WATTS BAR NUCLEAR PLANT (WBN) UNIT 1 - AMERICAN SOCIETY OF MECHANICAL ENGINEERS (ASME) SECTION XI, INSERVICE INSPECTION - REQUEST FOR RELIEF 1-RR-05 - APPLICATION OF CODE CASE N-597-1, REQUIREMENTS FOR ANALYTICAL EVALUATION OF PIPE WALL THINNING - RESPONSE TO REQUEST FOR ADDITIONAL INFORMATION (TAC NO. MC 1580)

WATTS BAR NUCLEAR PLANT (WBN) UNIT 1  
RESPONSE TO REQUEST FOR ADDITIONAL INFORMATION  
REQUEST FOR RELIEF 1-RR-05

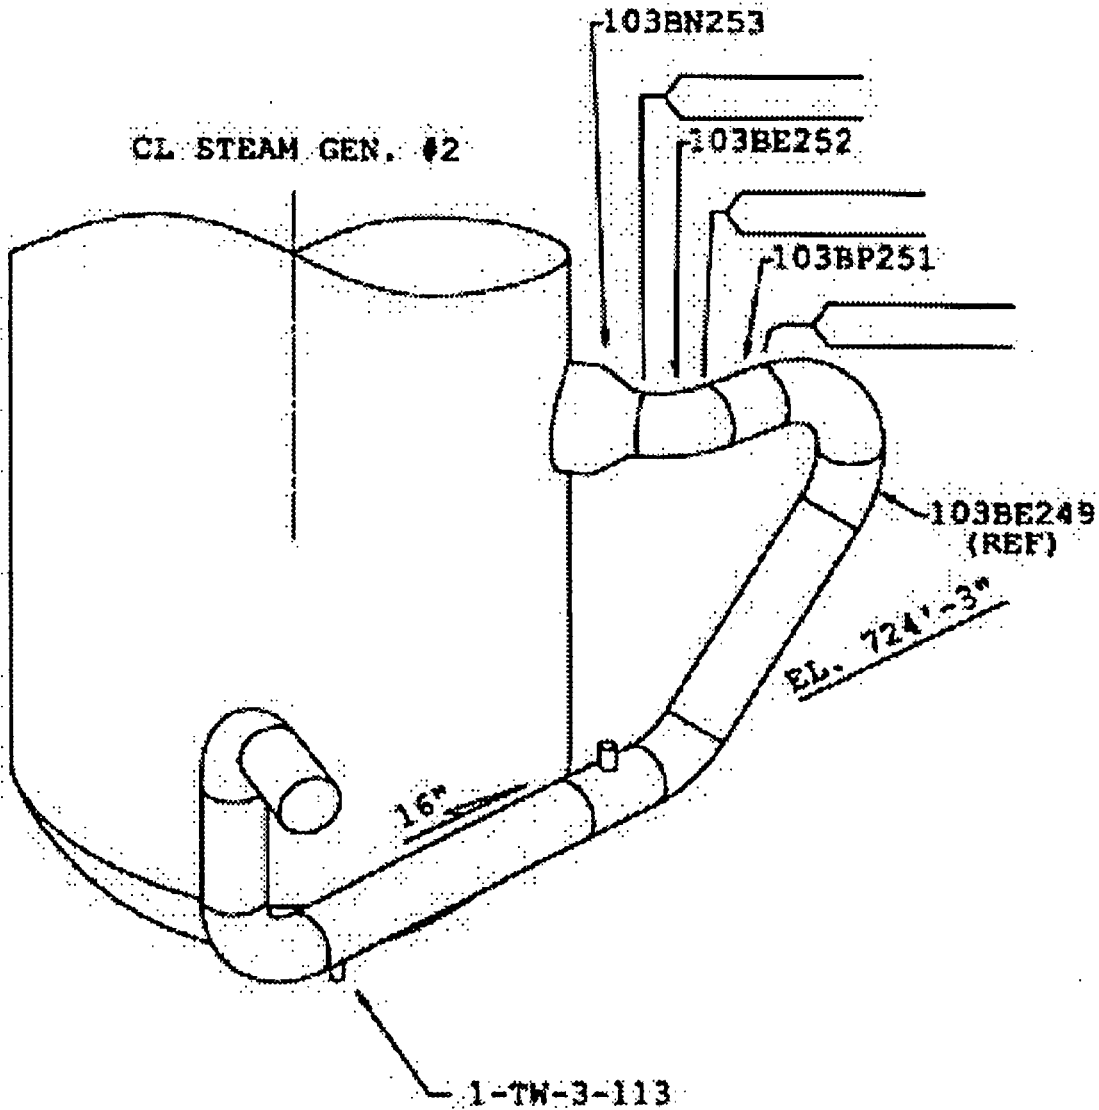
The smallest wall thickness was measured in a pocket within the larger corrosion area, as shown on this page. Provide the cause of these two localized corrosion pockets.

It should be noted that the region under discussion has not been classified by WBN as a "corroded" region. It is a region where the initial Ultrasonic Testing (UT) inspection shows certain areas/locations to be thin. As in any component where a thin area is detected during FAC UT inspection, the thin area is treated as FAC from an evaluation viewpoint.

With regard to the potential cause of the thinned condition, an attempt was made to perform a boroscopic inspection of the internal condition at these thin areas when this condition was discovered during the recent U1C5 Refueling Outage. This attempt was unsuccessful due to a pipe whip restraint which prevented the removal of a gamma plug to provide access. As a result, WBN was unable to provide the definitive cause of the two thin areas as requested. As stated originally, these thin areas are not in a location or an orientation typical of FAC. It is highly suspected the areas are an artifact from construction due to internal grinding related to counterboring. Future evaluations will provide further experiential data to enable a more precise determination of the cause of the thinned areas.

WATTS BAR NUCLEAR PLANT UNIT 1  
MONITORING PROGRAM FOR  
FLOW-ACCELERATED CORROSION TI-31.021  
GRID ID# 103BE252

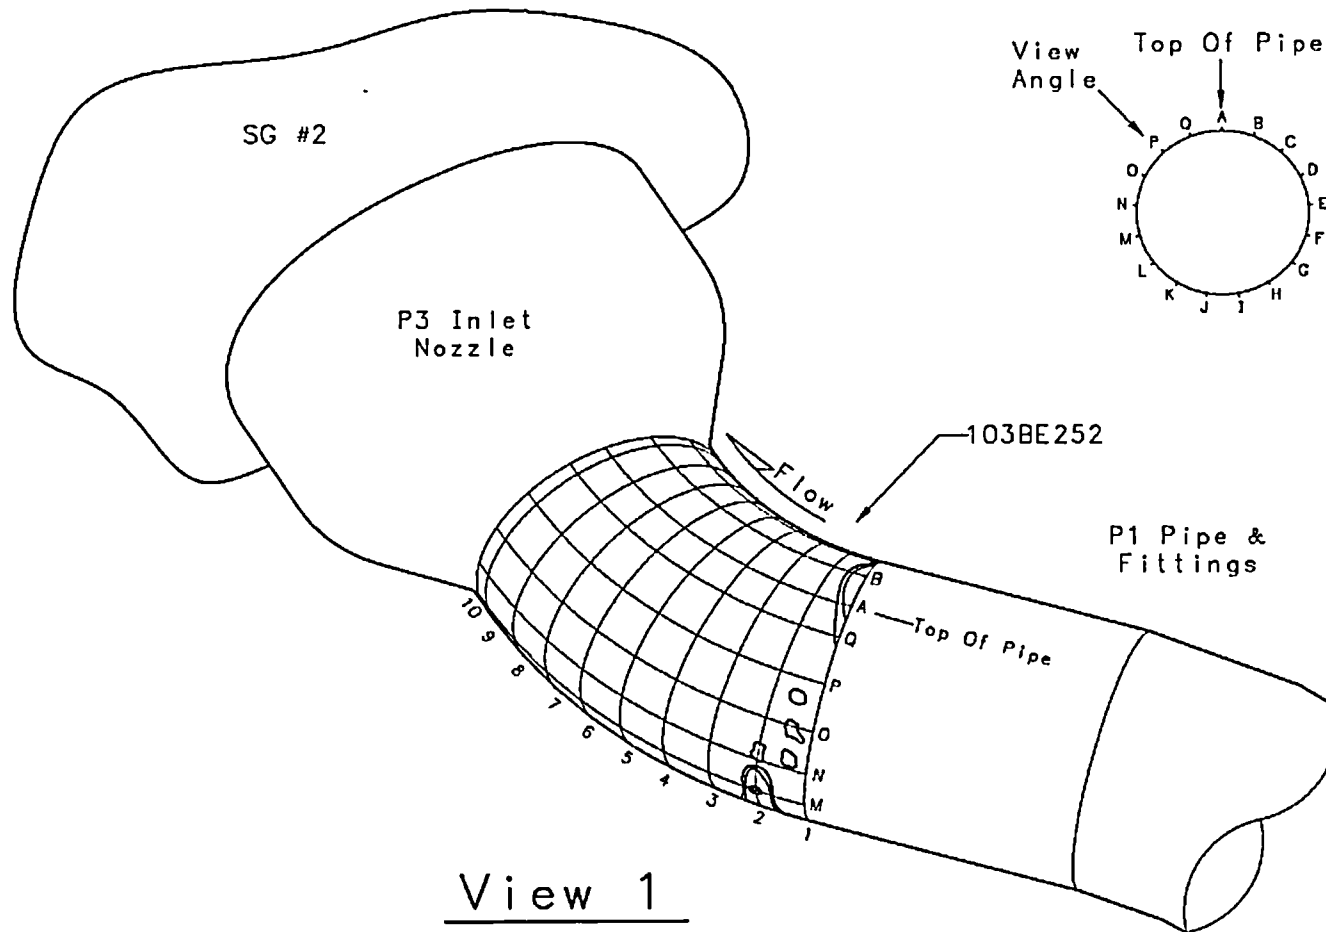
Provide a drawing of the grid corresponding to the table on page E1A2-1. Indicate the location of the grid origin "A1." Indicate if the grid is of uniform size, 3 x 3 inches, over the entire surface. Show the direction of the fluid flow.

On page E1A1-5, provide the dimensions of the corroded region. Locate this corroded region on the drawing requested in Item 2.

Three drawings/sketches are attached. The first is referred to as the "Grid Sketch." It is a general view of the main grid and any upstream and/or downstream grid associated with it during the inspection. A Grid Sketch is in all of the inspection packages. The Grid Sketch is intended to provide the inspector and the evaluator a picture of the component being considered, its location, its orientation, and its upstream/downstream components. It does not have grid lines drawn on it. "View 1" and "View 2" were drawn specifically to address Questions 2, 3, and 8. The direction of fluid flow is shown in each of the drawings/sketches.

- a. The grid origin ("A1") is located at the upstream (inlet) end of the elbow at the 12:00 o'clock position of the horizontal elbow. The intrados, line "E" in the sketches, is located at approximately the 3:00 o'clock position and the extrados, line "N" in the sketches, is located at approximately the 9:00 o'clock position.

- b. The grid size is not uniform over the external surface of the elbow. The grid size is a maximum of 3 x 3 inches.
- c. TVA's procedure for applying the grid is based on the component's diameter and specifies that for a component diameter of this size (16-inches), a 3-inch maximum grid is allowed. The grid is allowed to be smaller. Typically, the gridders would start at the origin and apply a 3-inch grid around the circumference of the component allowing the last space to "float" (be a smaller space). For instance, 3-inch x 16 spaces equals 48 inches and 3-inch x 17 spaces equals 51 inches. The circumference should measure 50.26 inches. So the last space (between "Q" and "A") will measure approximately 2.25 inches (50.26 inches - 48 inches) instead of 3 inches. This takes care of the grid lines in the longitudinal direction.

The thin areas/locations are identified on View 1 and View 2 as requested.

- The longest area, identified as being 0.721 inches bound, is 9 inches long x  $1 \frac{5}{16}$  inches wide.
- The next area, identified as being 0.700 inches bound, is 8 inches long x  $1 \frac{9}{16}$  inches wide.
- The area identified as 0.650 inches bound, and containing the 0.639 inches thinnest value, is  $\frac{15}{16}$  inches long x  $\frac{3}{4}$  inches wide.
- The area identified as 0.650 inches bound, and containing the 0.646 inches thin area, is 1-inch long x  $\frac{9}{16}$  inches wide.
